Harrell Design Group, PC AMENDMENT 02 July 11, 2024

RENOVATE SPACE FOR LOGISTICS (B-1) VA PROJECT #564-24-104

Veterans' Healthcare System of the Ozarks

HDG Project Number: 19022-A

PROJECT NUMBER 564-24-104 BUILDING NUMBER DRAWING NUMBER AF602-A CHECKED DRAWN

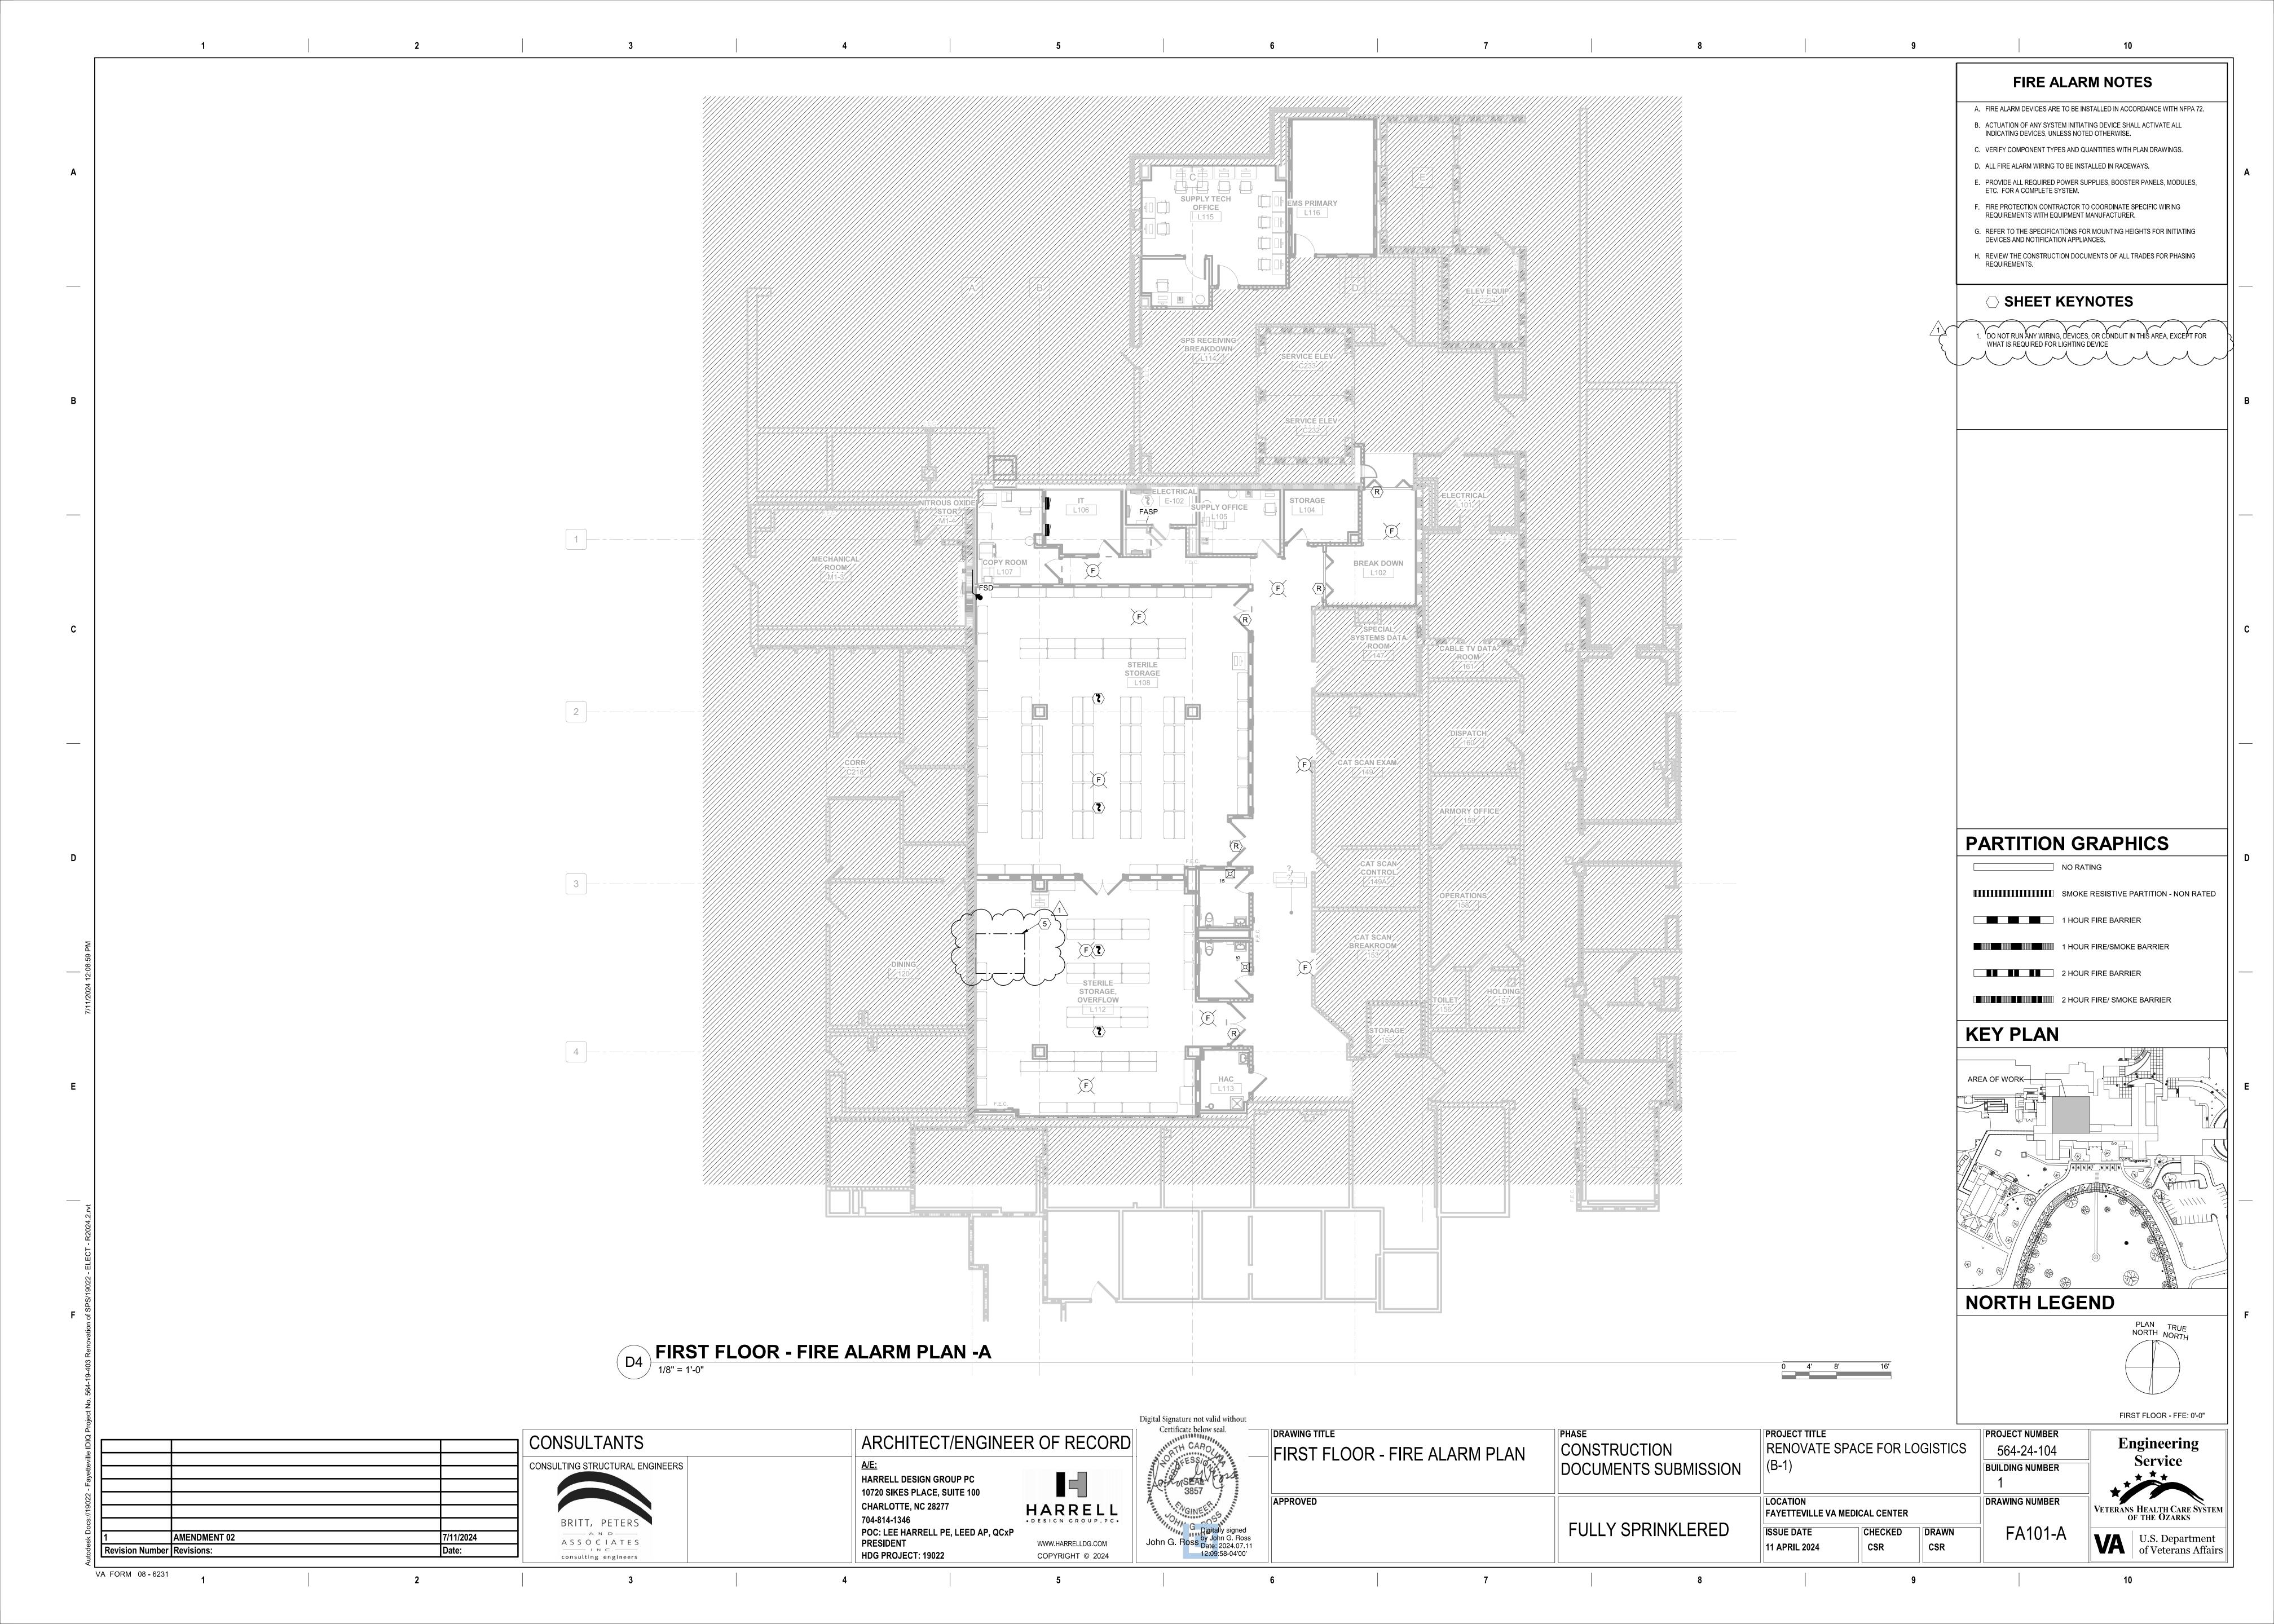
- i. The Signage Schedule was updated to reflect the correct room names, room numbers, and quantities of all signage.
- ii. Corridor L109 was added to the Finish Schedule.
